## Addendum No. 04

**TO: PLANS AND SPECIFICATIONS FOR STATE OF MISSOURI**

Elevator Replacement  
Governor's Mansion  
Jefferson City, MO  
Project No: O2036-01

**SHEET TITLE:  
DEMOLITION  
FLOOR PLAN AND  
ROOF PLAN**

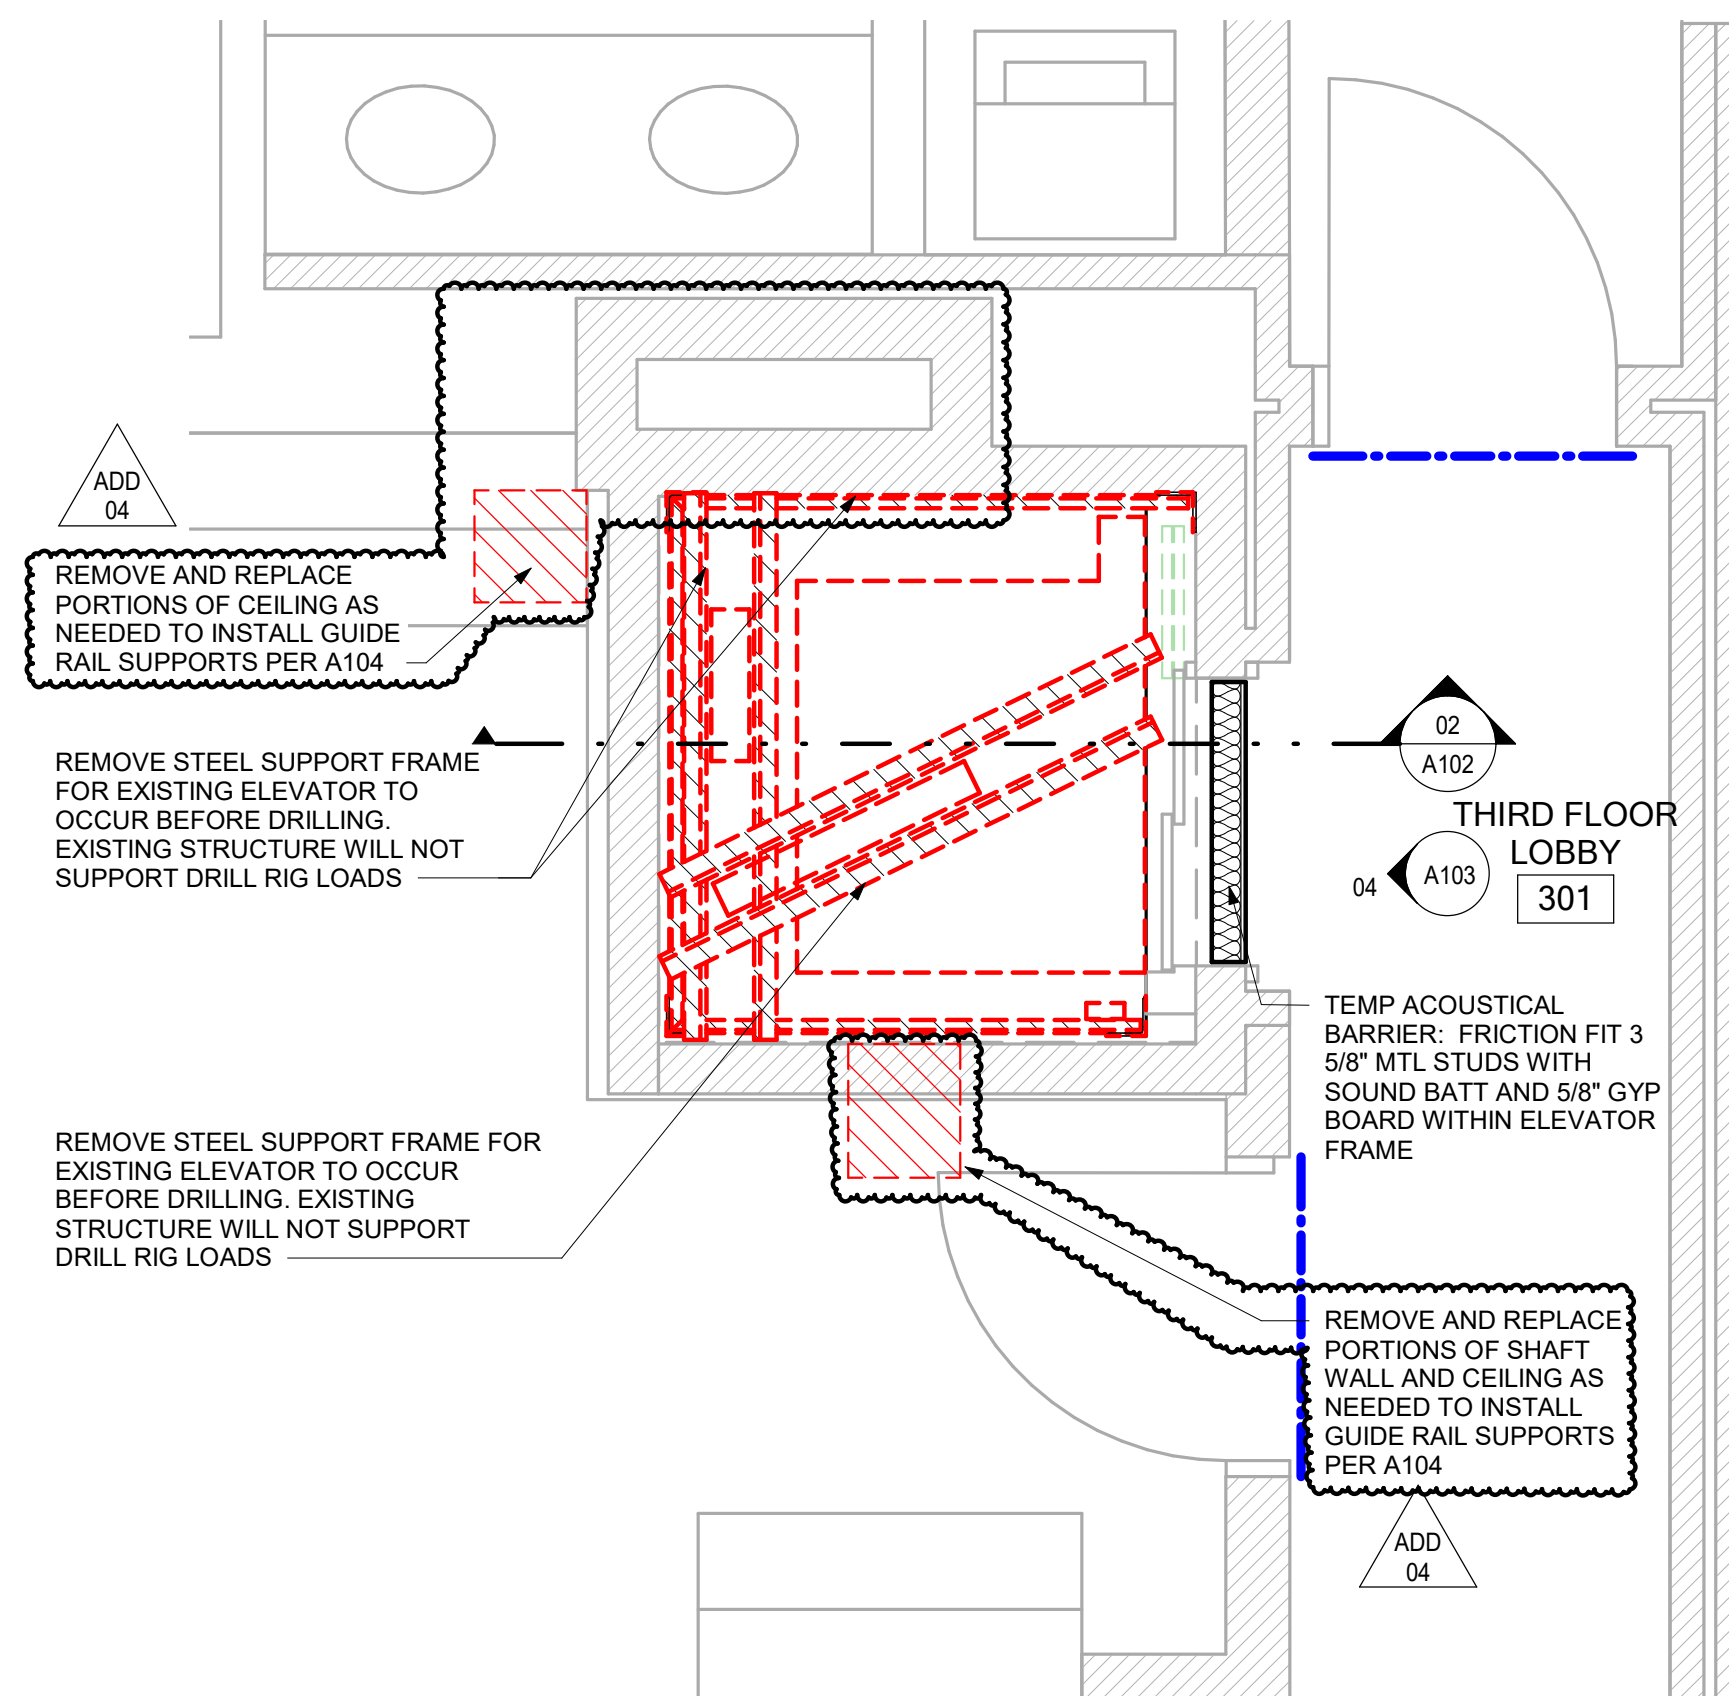
1. Drawing A101:
  - a. *Revise details 01, 02, 03, and 04 to show*
    - a. *Estimated location of existing masonry chimney.*
    - b. *Wall and ceiling demolition necessary to install guide rail bracing*

**03 HOISTWAY SECTION NORTH**  
A102/A102 1/4" = 1'-0"

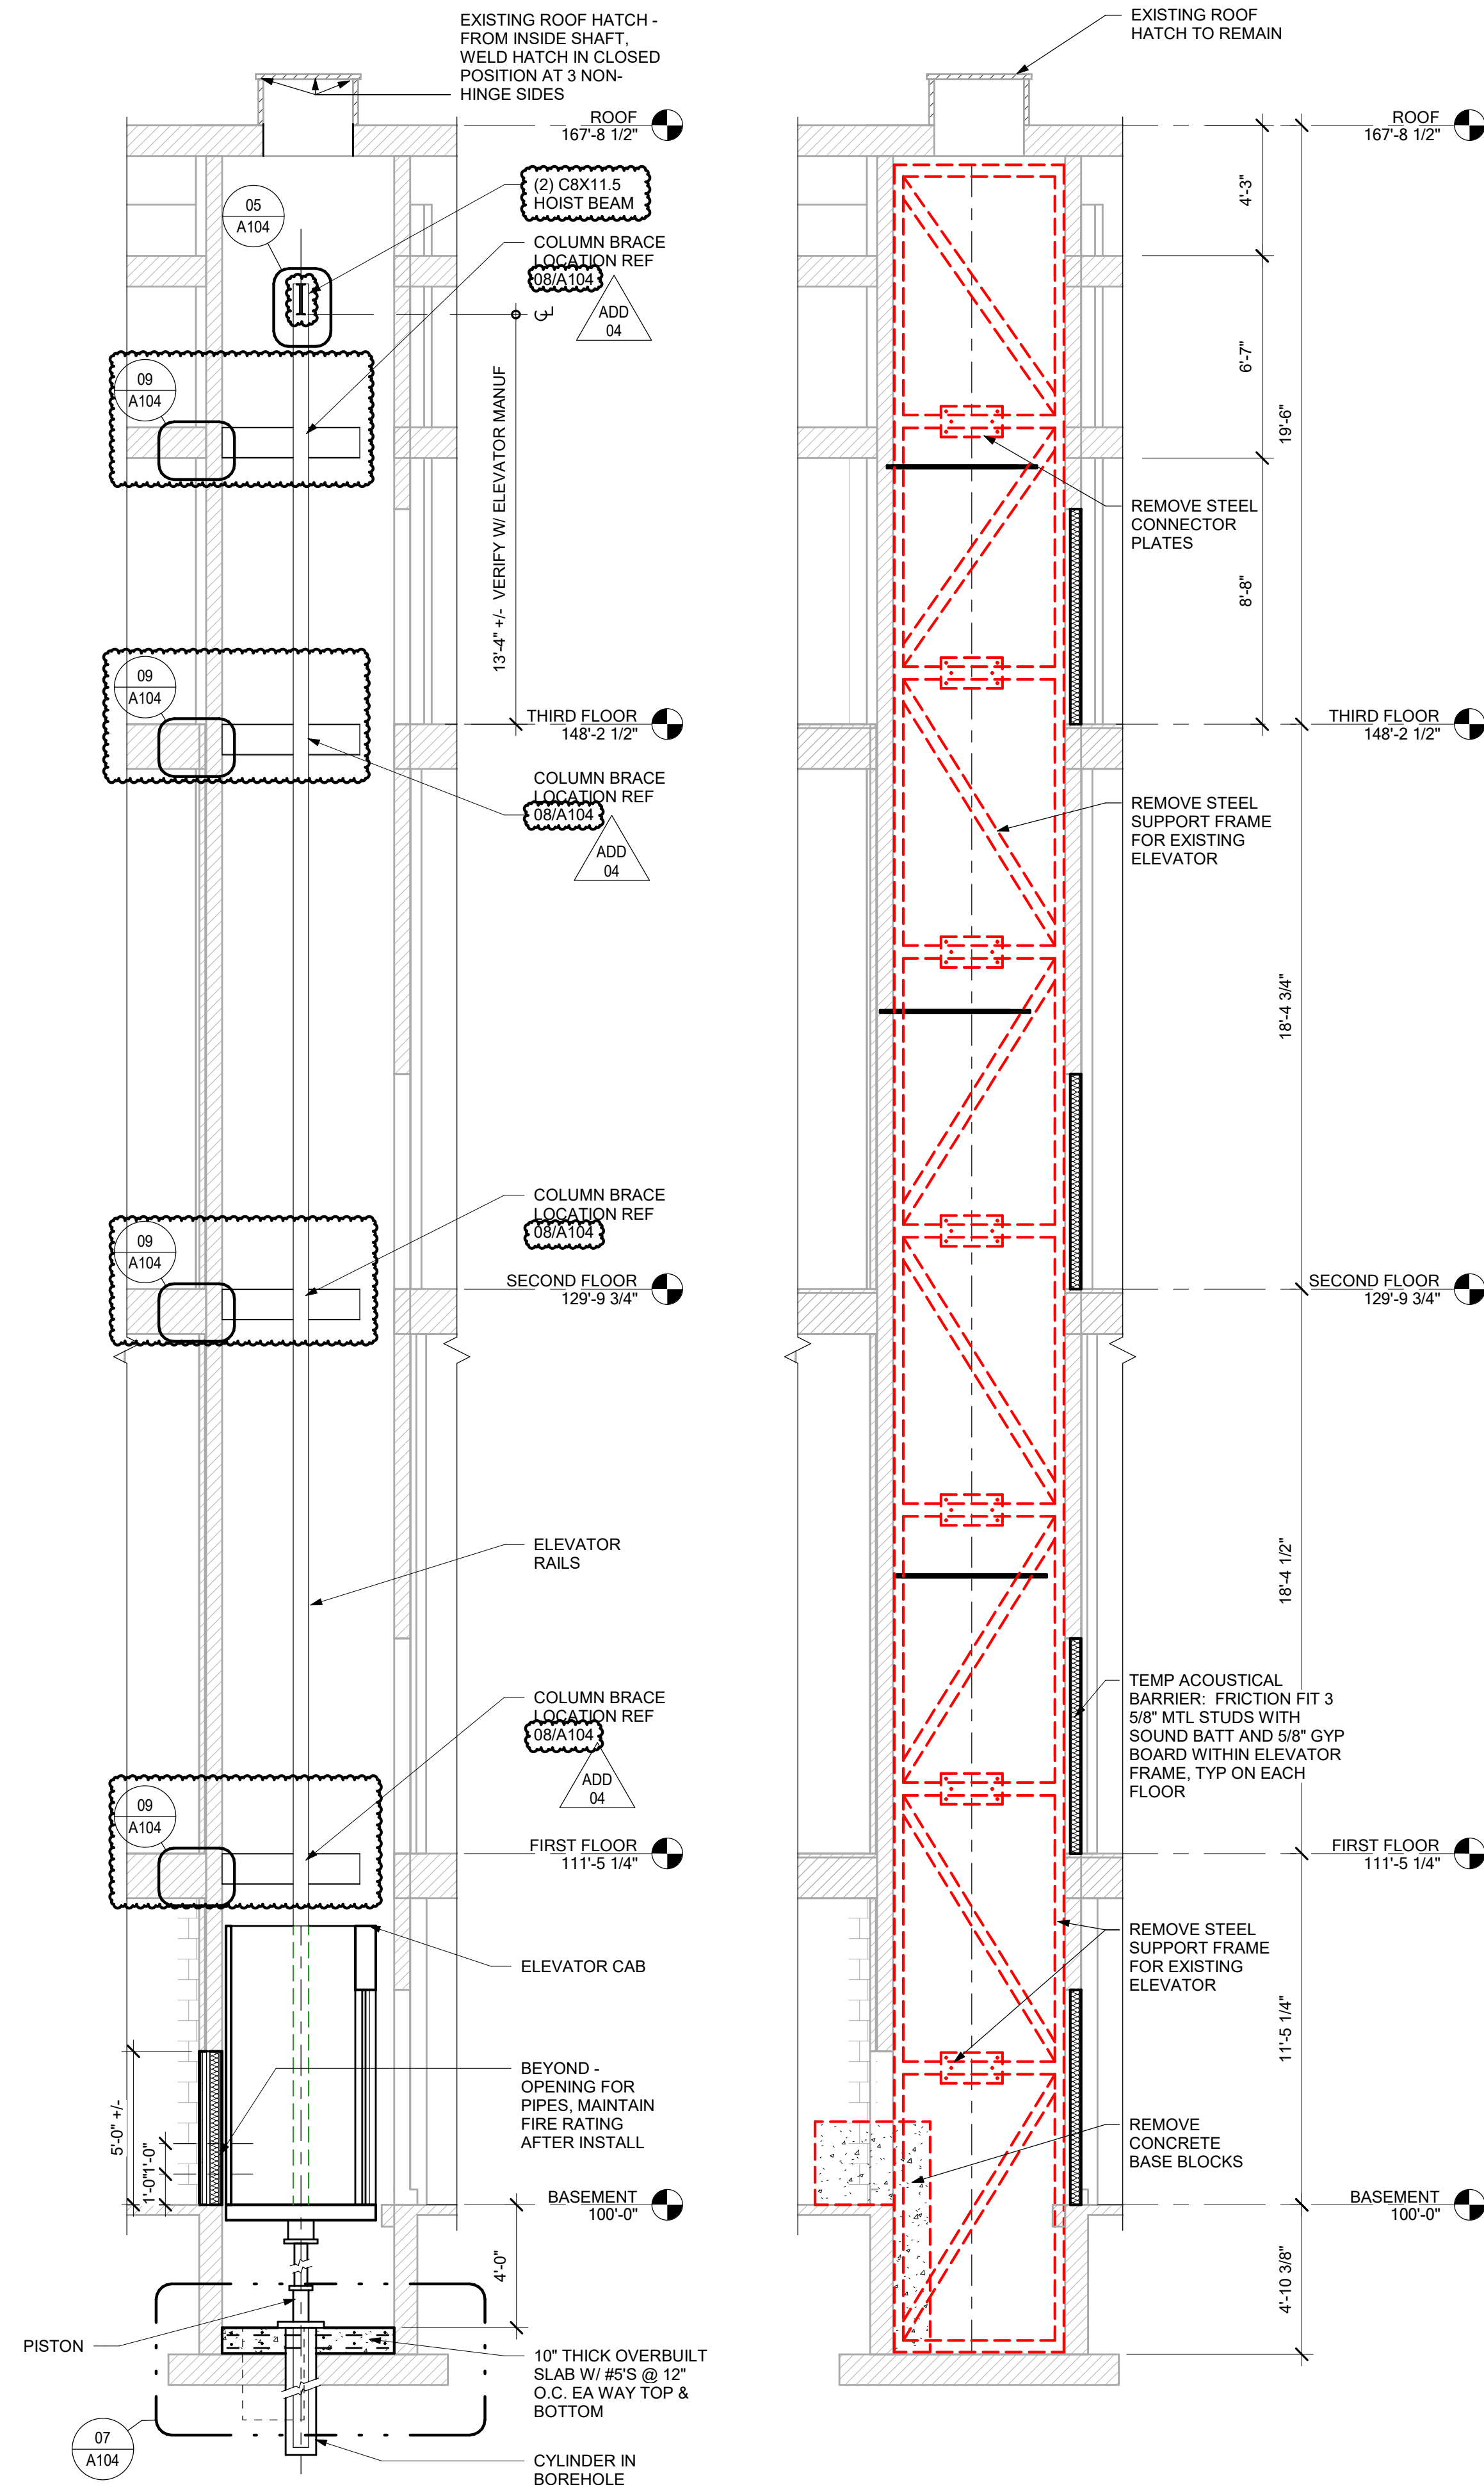
- 3) *New plan detail callout added at southwest elevator shaft wall and guide rail*
  - b. *Revise detail 03 to show*
    - 1) *Location of C-channel guide rail supports at northeast elevator shaft wall, and update the referenced plan detail*

- 2) *Add section detail callout where C-channel guide rail support attaches to shaft sidewall in north corner.*
    - 3) *Revised hoist beam*
3. Drawing A104:

**01 NEW WORK - BASEMENT**  
A102 1/2" = 1'-0"

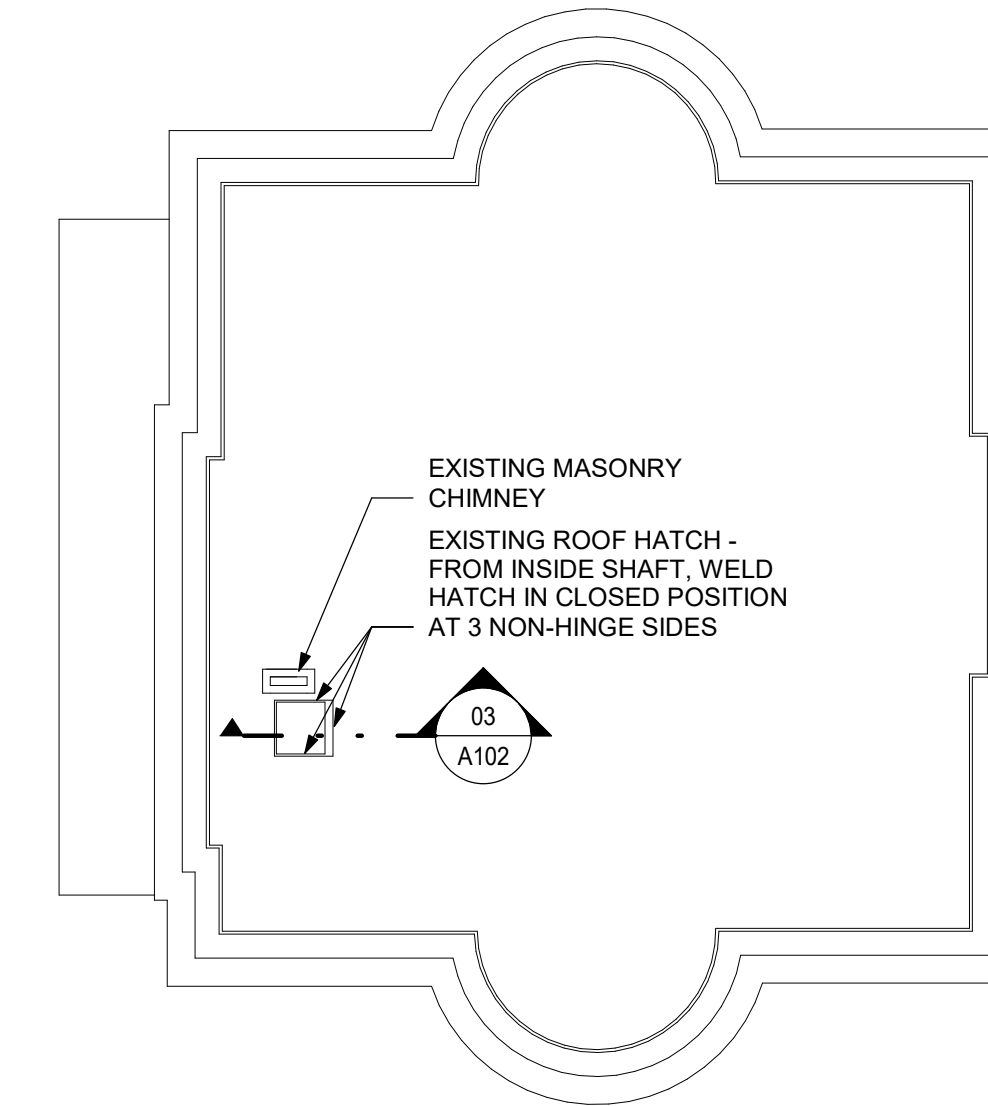
2. Drawing A102:
  - a. *Revise detail 01 to show*
    - 1) *Estimated location of existing masonry chimney*
    - 2) *New plan detail at northeast elevator shaft wall and guide rail at estimated location of existing masonry chimney*

**09 NORTH GUIDE RAIL BRACING**  
A102/A104 3" = 1'-0"

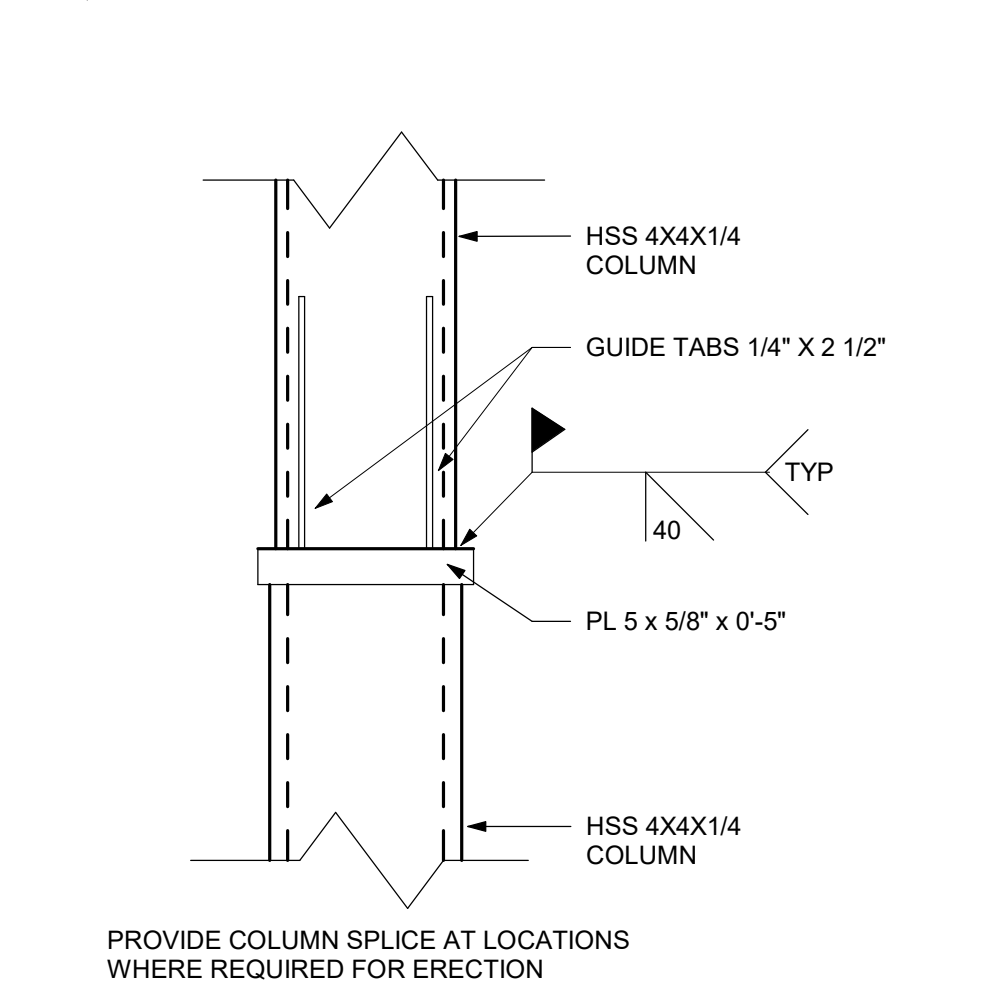
- b. *Revise detail 04 to show section cut callout to existing detail 02/A104.*
- c. *Revise detail 05 to show:*
  - 1) *Revised to indicate new hoist beam construction and space plates*
  - 2) *Left side of detail indicates southwest elevator shaft wall guide rail, which will stop below the hoist beam*
  - 3) *Extended detail to show northeast elevator shaft wall guide rail, which will provide support of the hoist beam at this side of the shaft*
- d. *Add detail 08 to show guide rail support at the northeast elevator shaft wall*
- e. *Add detail 09 to show attachment of guide rail support at the north elevator shaft corner*

**03 COL AND BP AT RAIL - PLAN DETAIL - SOUTHWEST WALL**  
A102/A104 3" = 1'-0"

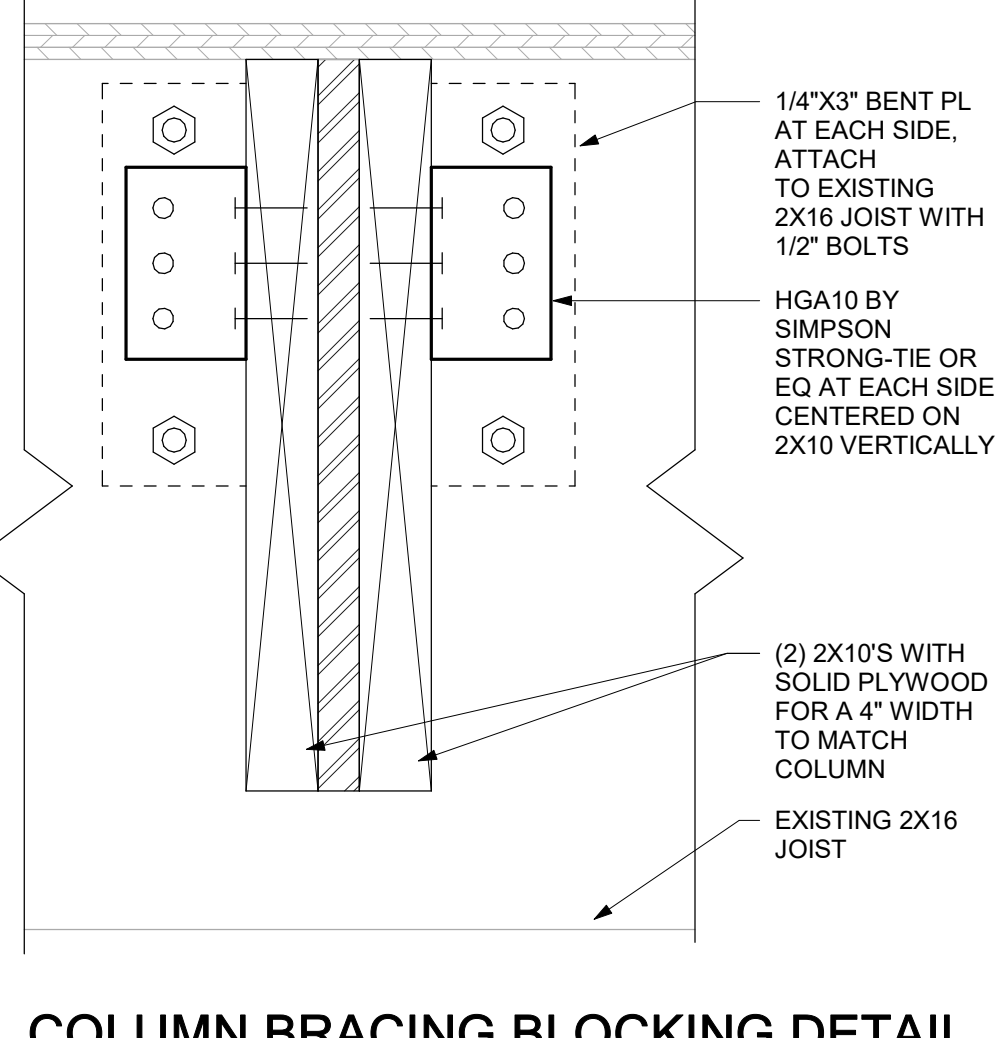
- a. *Revise detail 03 to show plan detail location at the southwest wall of the elevator shaft at wood stud wall construction.*
